FirstEnergy Nuclear Operating Company

October 29, 2001
L-01-113

Subject: Beaver Valley Power Station, Unit No. 1 and No. 2
BV-1 Docket No. 50-334, License No. DPR-66
BV-2 Docket No. 50-412, License No. NPF-73
License Amendment Request Nos. 281 and 152

Pursuant to 10 CFR 50.90, FirstEnergy Nuclear Operating Company (FENOC) requests an amendment to the above licenses in the form of changes to the technical specifications (TSs). The proposed amendment revises the TS 3.9.3, "Refueling Operations – Decay Time," decay time of 150 hours to 100 hours.

Beaver Valley Power Station, Unit No. 2
License Amendment Request No. 152

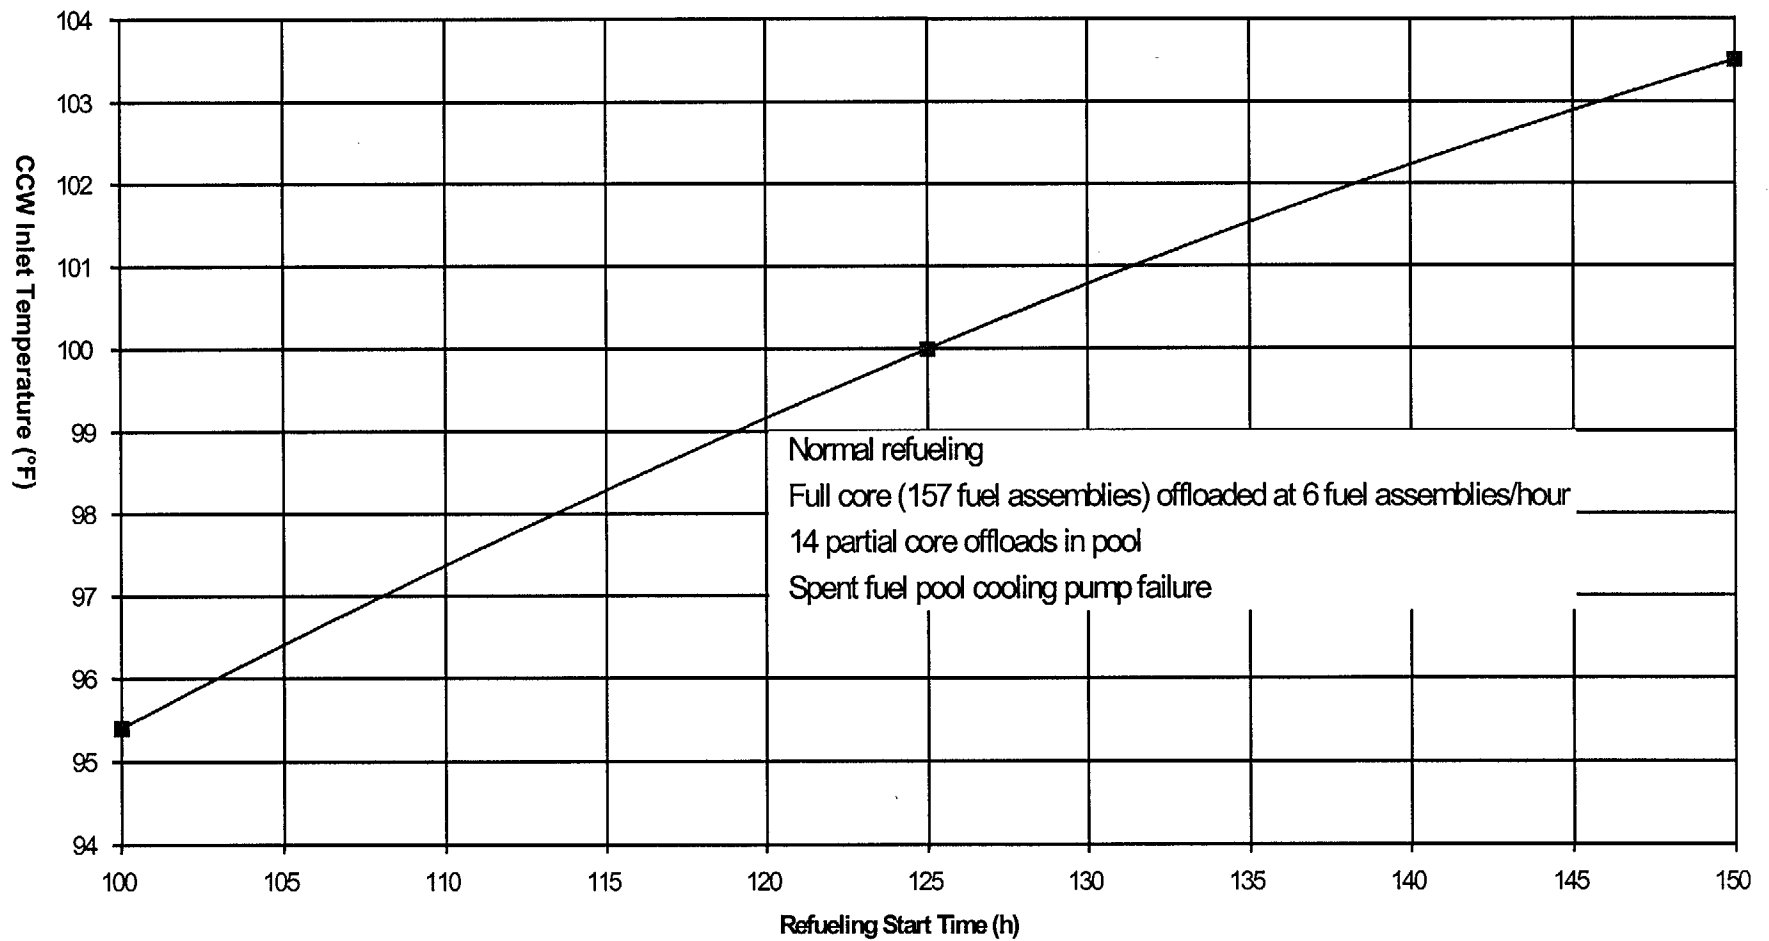
The re-analyses of SFP thermal-hydraulic performance included results for other decay times greater than 100 hours. These analytical results are combined into graphs of decay time versus component cooling water (CCW) inlet temperature representing the conditions that will limit the SFP temperature to 170 °F for Unit Nos. 1 and 2, respectively. These graphs are presented in corresponding Attachments D-1 and D-2. Administrative controls will be established in accordance with the commitment stated in Attachment E.

Administrative controls will be established to control decay times prior to the movement of irradiated fuel assemblies from the reactor core based on the "Decay Time versus Component Cooling Water" curves provided in Attachments D-1 and D-2.	Prior to refueling outages 1R15 and 2R10 for Units 1 and 2, respectively.
---------------------------------------------------------------------------------------------------------------------------------------------------------------------------------------------------------------------------------------------------	---------------------------------------------------------------------------
